South Texas Project Electric Generating Station P.O. Box 289 Wadsworth, Texas 77483

December 4, 2008
U7-C-STP-NRC-080067

South Texas Project
Units 3 and 4
Docket Nos. 52-012 and 52-013

Commitment Related to Tsunami Effects and Response to Request for Additional Information

Figure 1. Location of East Breaks slump relative to STP 3 & 4 (Source: Reference 11).
Bathymetry elevations are relative to Mean Sea Level (MSL).

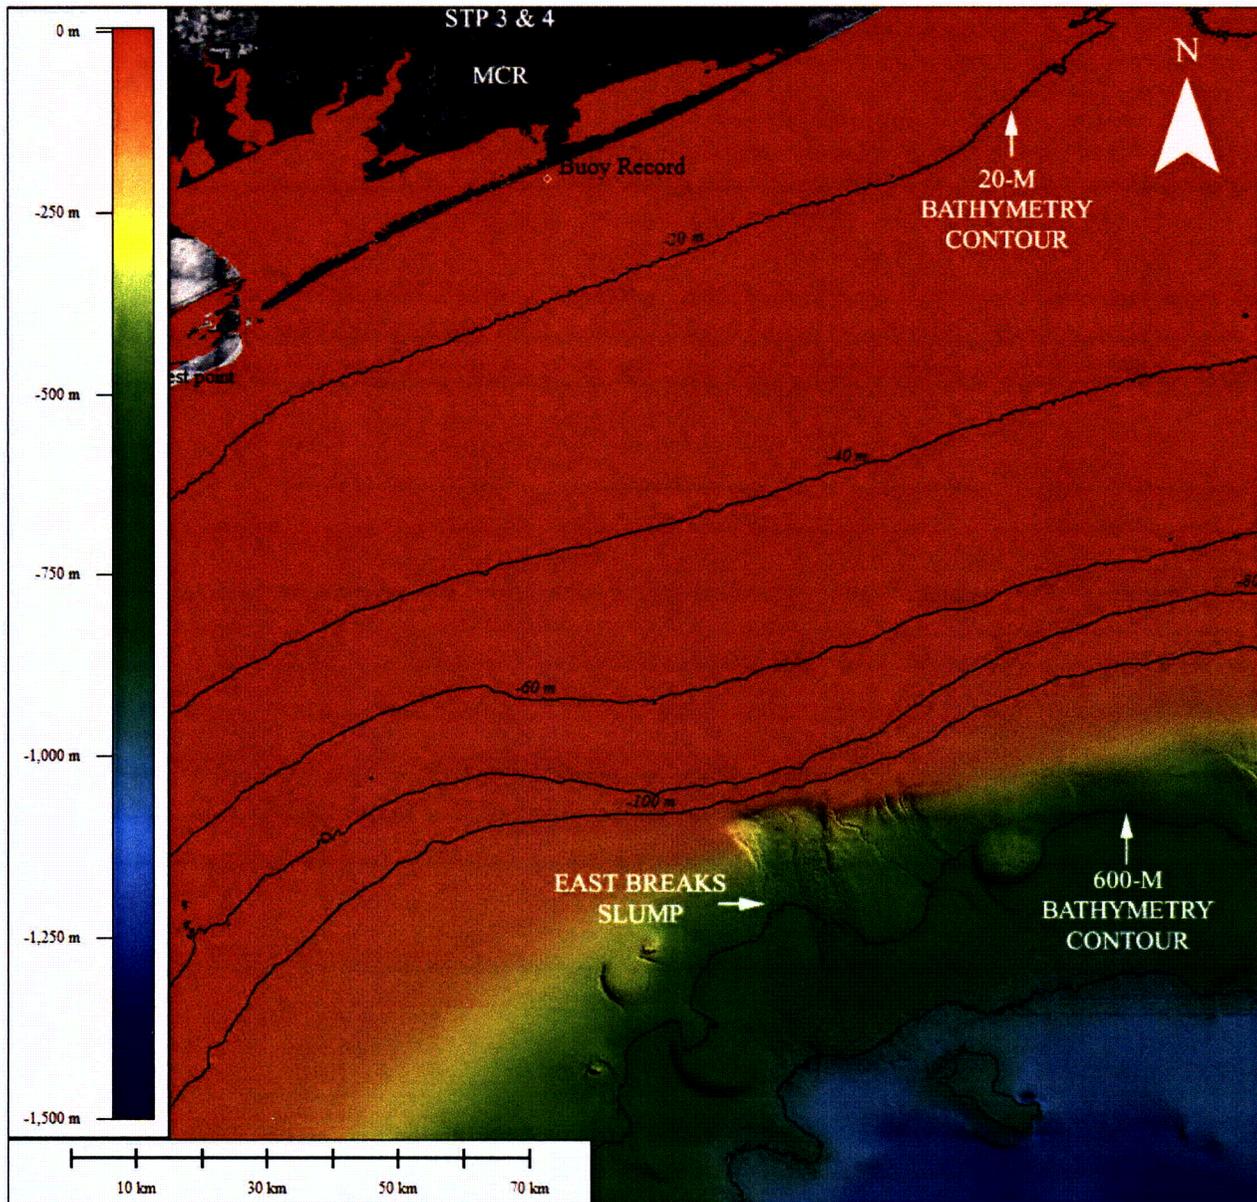
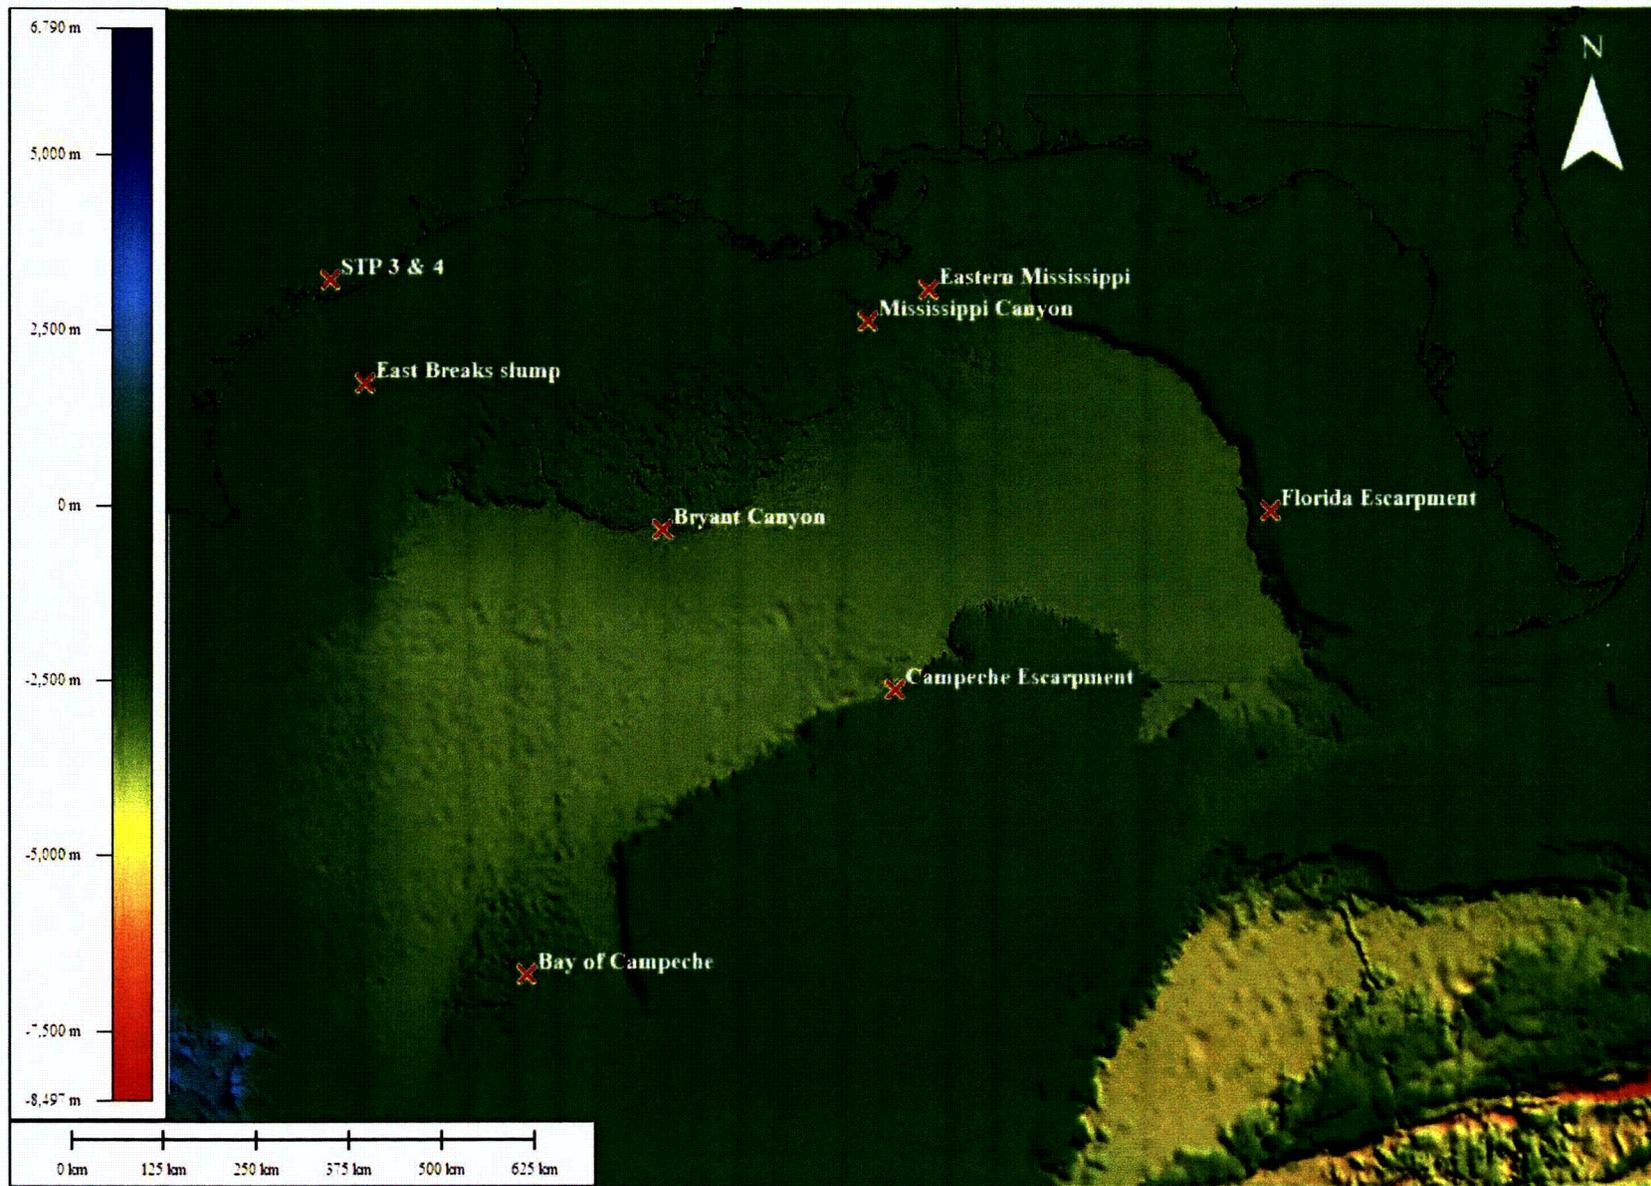
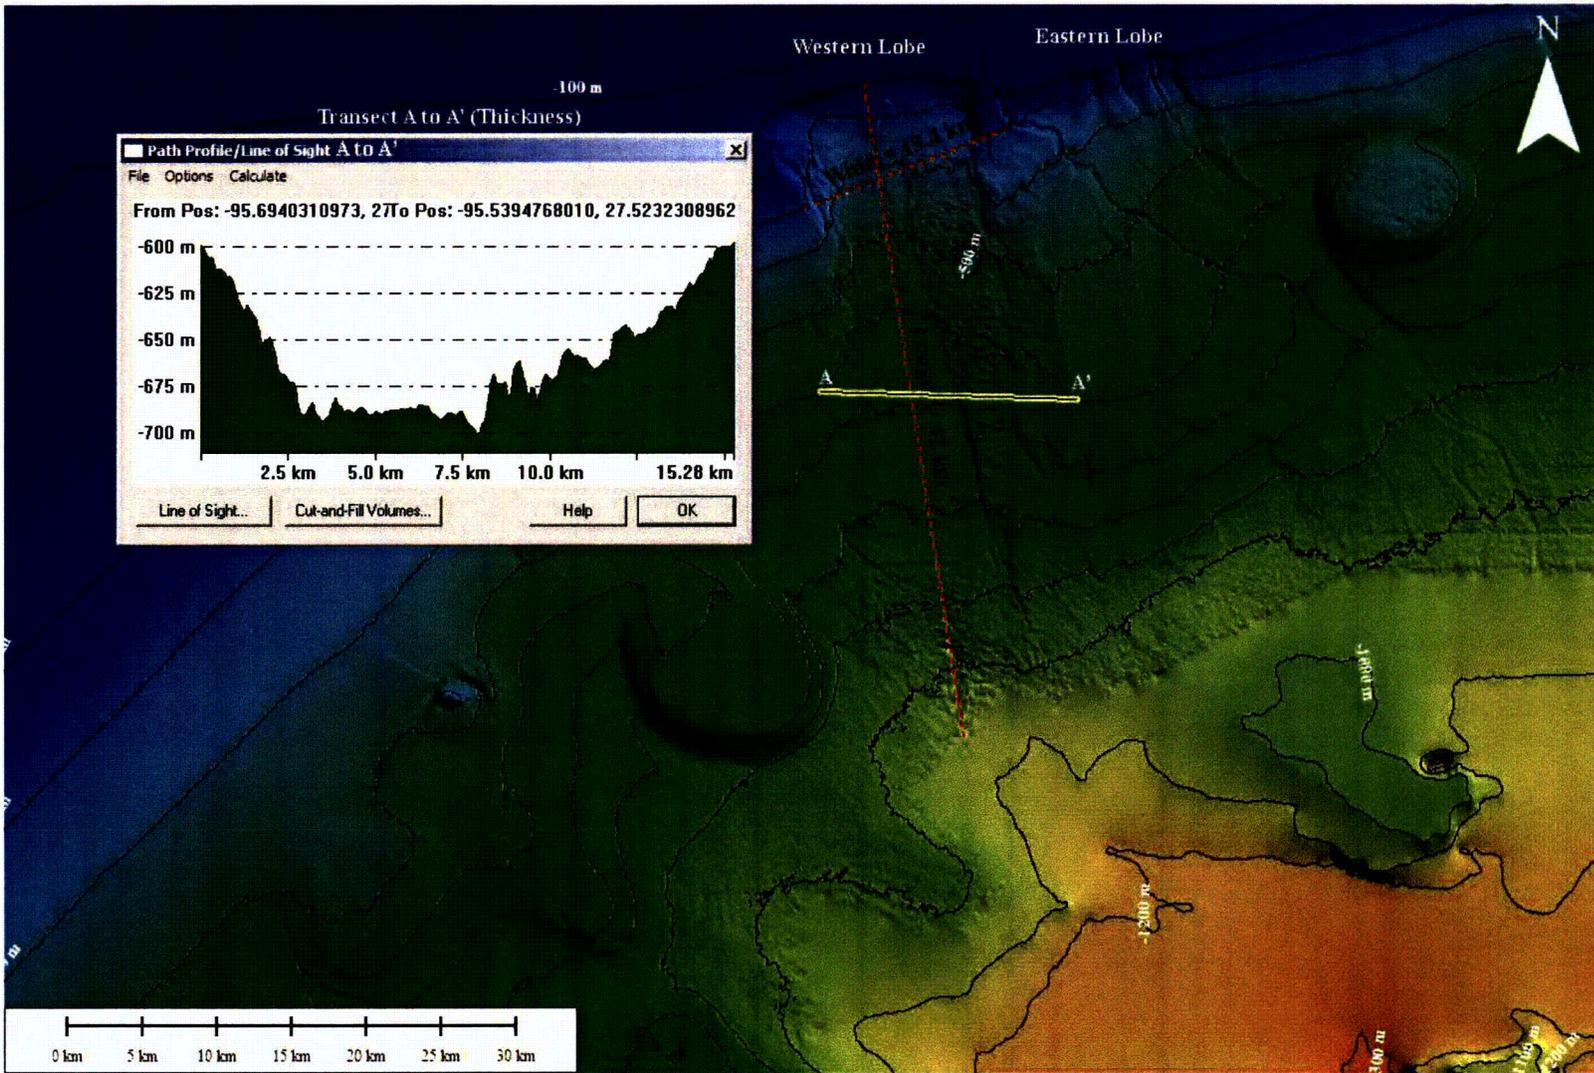
[Item 1] Provide an assessment (e.g., tsunami modeling analysis) of the East Breaks landslide to clarify whether the 7.6 m offshore wave height indicated by Trabant et. al. (2001) can be discounted.

In response to Item 1, Section C.I.2.4.6.1 of Regulatory Guide 1.206, and information provided in References 1 and 2, tsunami modeling was conducted for a submarine mass failure (SMF) originating at the East Breaks slump (Figure 1). A series of scaled dipolar initial conditions were used for bracketing possible minimum and maximum wave heights (References 3 and 4). Hydrodynamic simulations were modeled using a series of codes known as the Method of Splitting Tsunami (MOST) (References 5 and 6). For negative (i.e., drawdown) wave elevations of up to -140 m (-459 ft) and positive wave elevations of up to 60 m (197 ft), maximum predicted run-up along the South Texas coast did not exceed 2 m (6.6 ft) above Mean Sea Level (MSL).

The East Breaks slump is located approximately 142 km (88 mi) to the southeast of STP 3 & 4 (Figure 1 and Figure 2). The coordinates of the slump are approximately 27.57 °N and 95.64 °W. The slump consists of an eastern lobe and a western lobe (Figure 3) (References 7 and 8). Reference 8 states that “the western and eastern lobes are thought to have formed by two

Source parameters for the East Breaks slump were estimated using three arc-second bathymetry data from the National Geophysical Data Center (NGDC) (Reference 11). Source parameters, including slump width, length, and thickness, were estimated using a Geographic Information Systems (GIS) environment (Figure 3). Slump width was estimated to be approximately 13.4 km. The length of the erosional chute was estimated to be about 42 km. Based on a transect across the erosional chute, slump thickness was estimated to be about 100 m (i.e., see Path Profile A to A' in Figure 3). With respect to slope, Reference 2.4S.6-5 (i.e., Trabant et al., 2001) stated that “initial failure of the slump took place on very low angle slopes of less than two degrees while present slump deposits have an average seafloor slope of one-degree.” While a vertical drop of 850 m over a length of 42 km indicates a bed slope of approximately 1.1 degrees, a maximum local slope of 2 degrees was used from estimates in GIS as a conservative estimate. Similarly, initial depth of the slide was estimated conservatively using the 200-m and 1000-m bathymetry contour elevations. Therefore, initial depth was estimated to be 600 m (i.e., (200 m + 1000 m)/2) (Figure 1). The total length of the slide was estimated from Reference 1 as 114 km.
